**LOCAL HISTORIC DISTRICT:** Wilmore

**PROPERTY ADDRESS:** 429 West Park Avenue

**SUMMARY OF REQUEST:** Painted Brick/Front Door Replacement

**HDCRMI 2019-00444**

## FRONT PORCH LEFT COLUMN

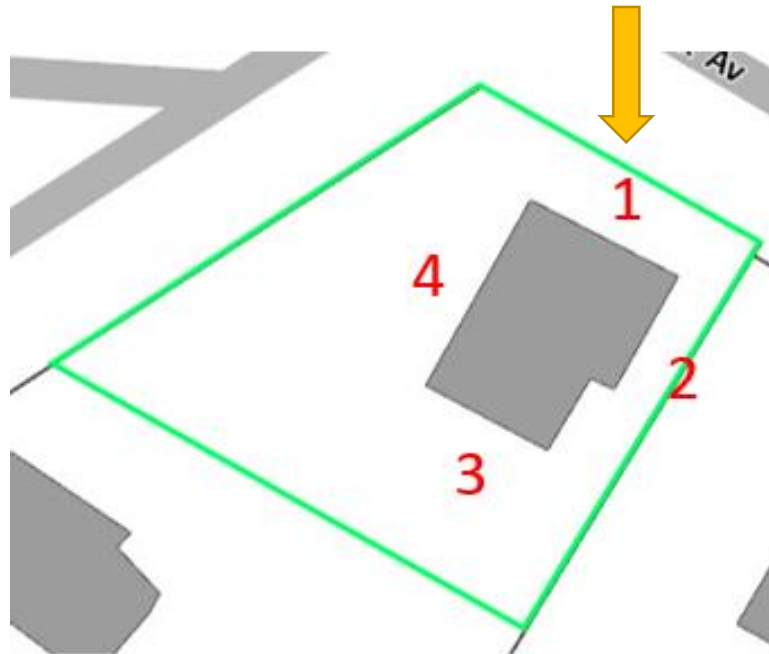
- Mismatched brick (smooth and scored face)
- Inconsistent mortar head (vertical) joint widths
- Uneven & un-tooled joints
- Broken brick & mortar drips

## FRONT PORCH RIGHT COLUMN

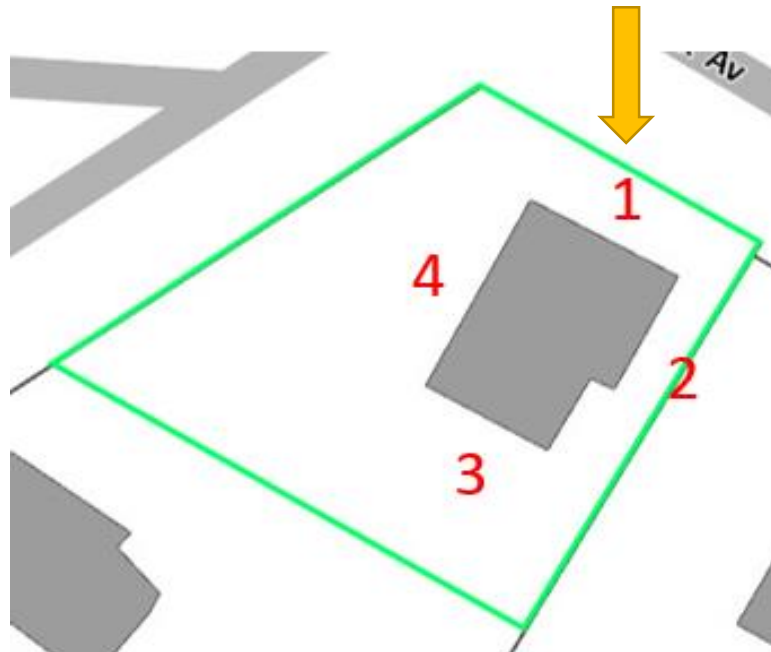
- Caved in brick
- Crooked and irregular joints
- Broken brick
- Substandard mortar and joint lines
- Inferior masonry workmanship

## FRONT PORCH RIGHT COLUMN

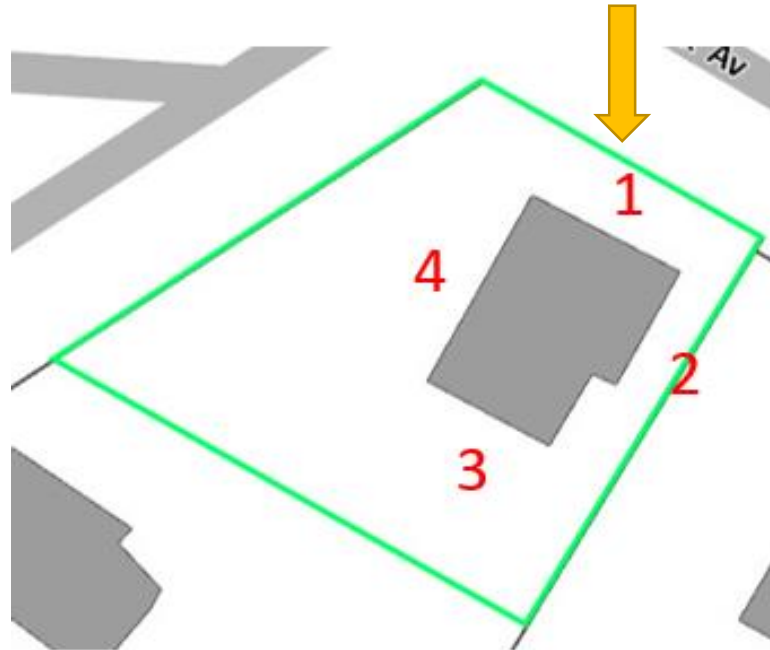
- Inconsistent mortar joints
- Crooked and irregular joints
- Substandard mortar and joint lines

## NORTHWEST SIDE FRONT PORCH

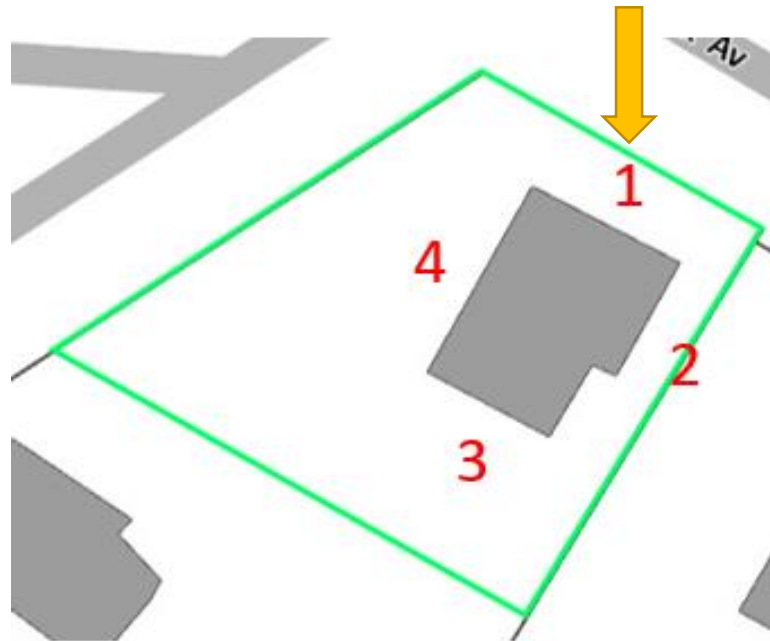
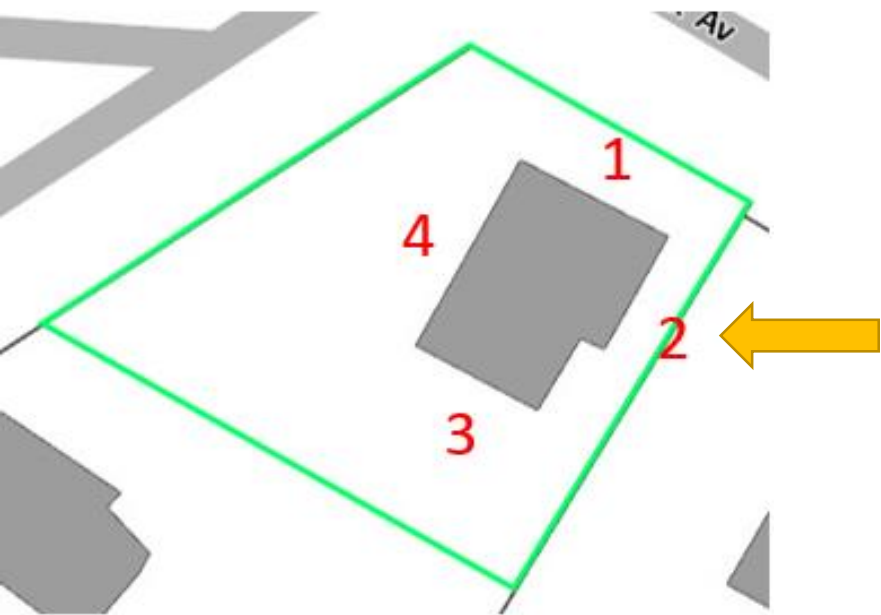
- Overfilled mortar joints
- Mismatched brick
- Uneven rows of brick at the joint.
- Inferior masonry workmanship

## EAST SIDE COLUMN

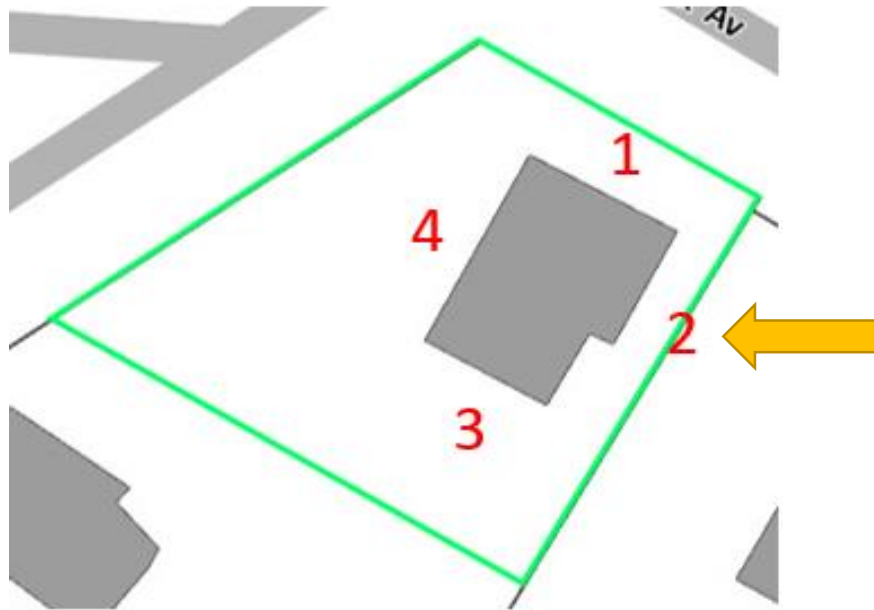
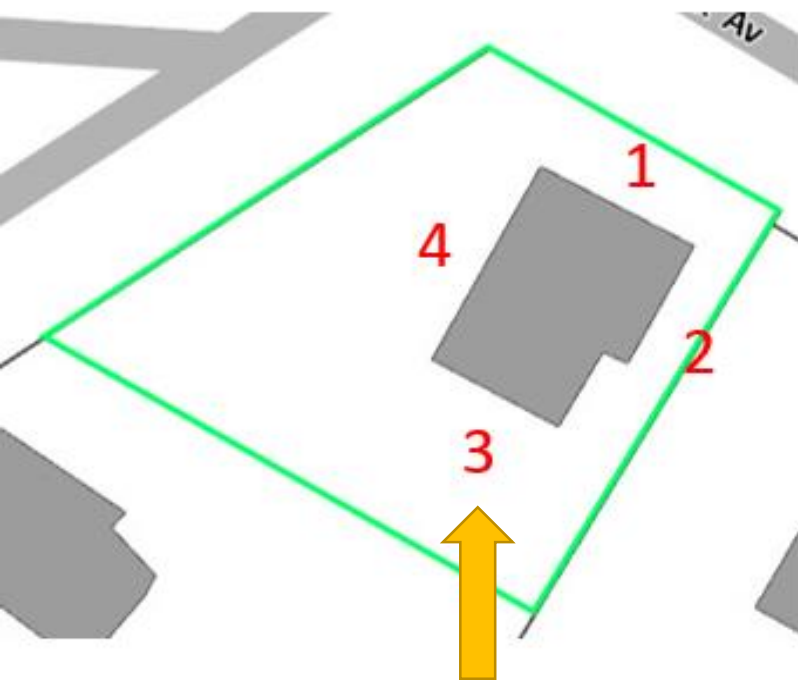
- Under-filled & mismatched mortar (horizontal & vertical) lines
- Inferior masonry workmanship.
- Uneven rows and substandard mortar and joint lines

## SOUTH SIDE

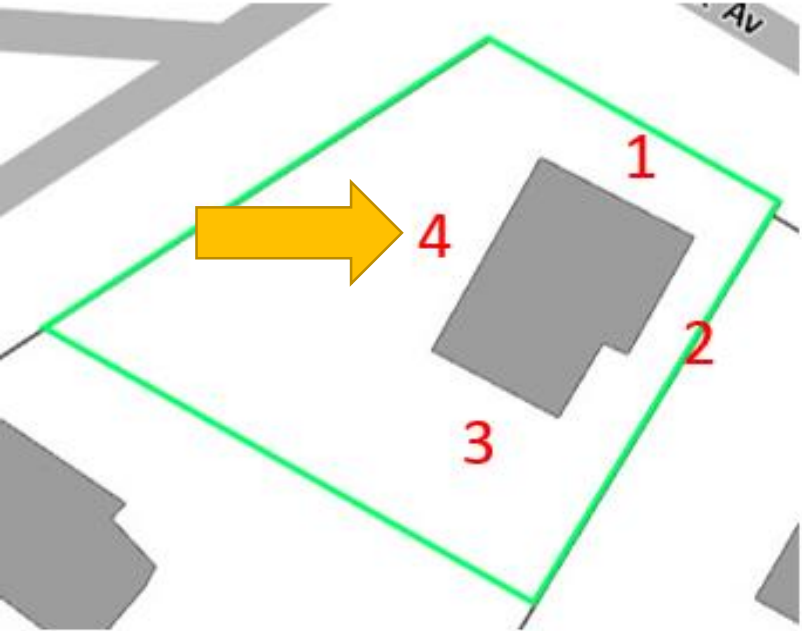
- Mismatched mortar (horizontal & vertical) lines
- Joint lines don't line up in brick pattern.
- Uneven rows and substandard mortar and joint lines

## WEST SIDE

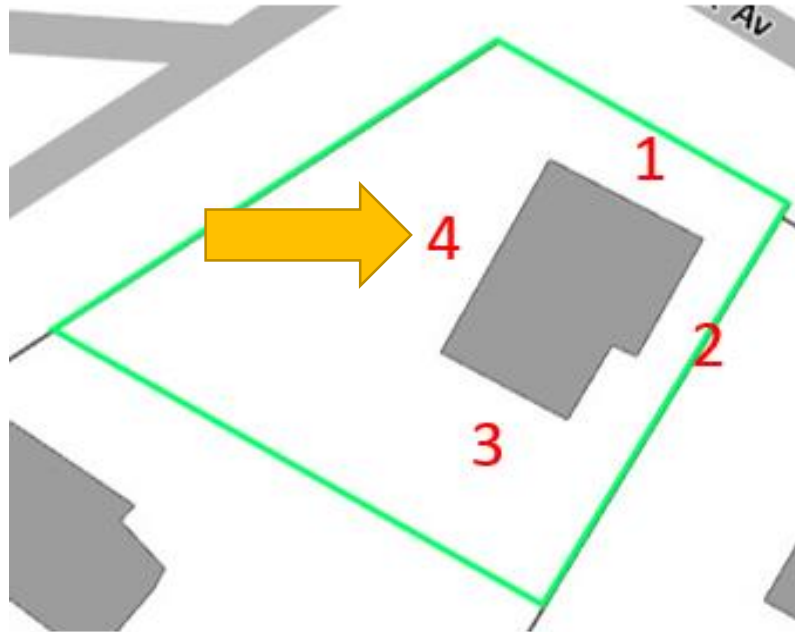
- Excessive and sloppy mortar work
- Uneven joint lines
- Bricks don't line up

- Mortar head joints in excess of 1 inch common throughout all sides of house.
- Industry standard is  $\frac{3}{8}$ "

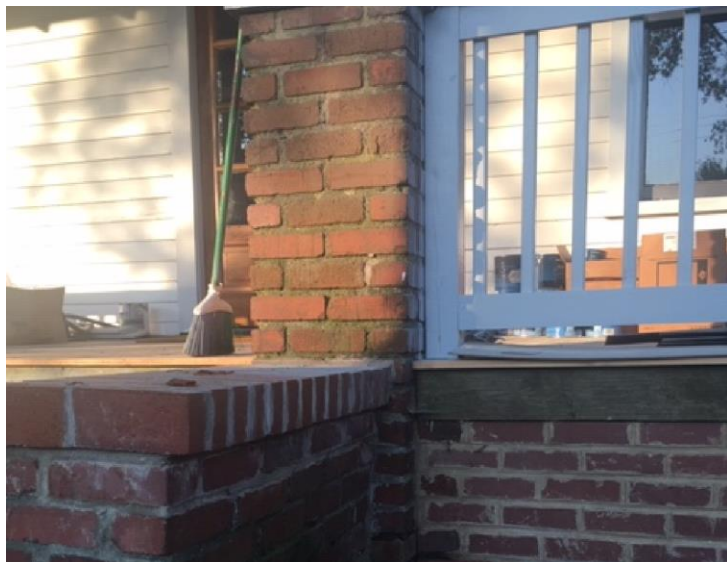
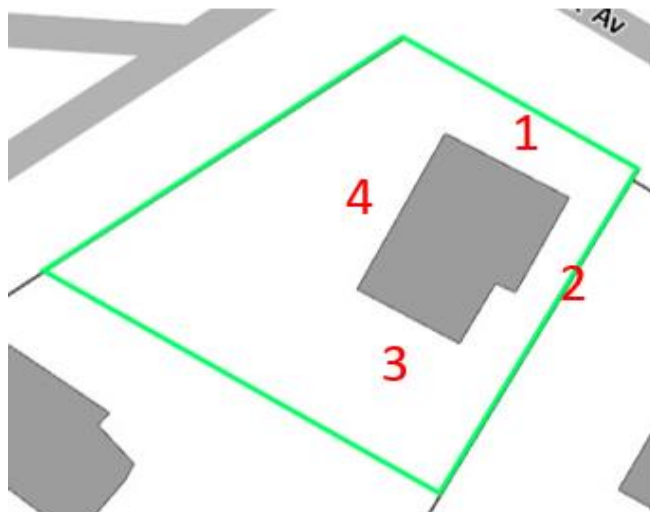
- Original front door | 15-light
- Serious disrepair with broken panes and wood rot.

- Replaced with a custom, solid wood, 8-light door.
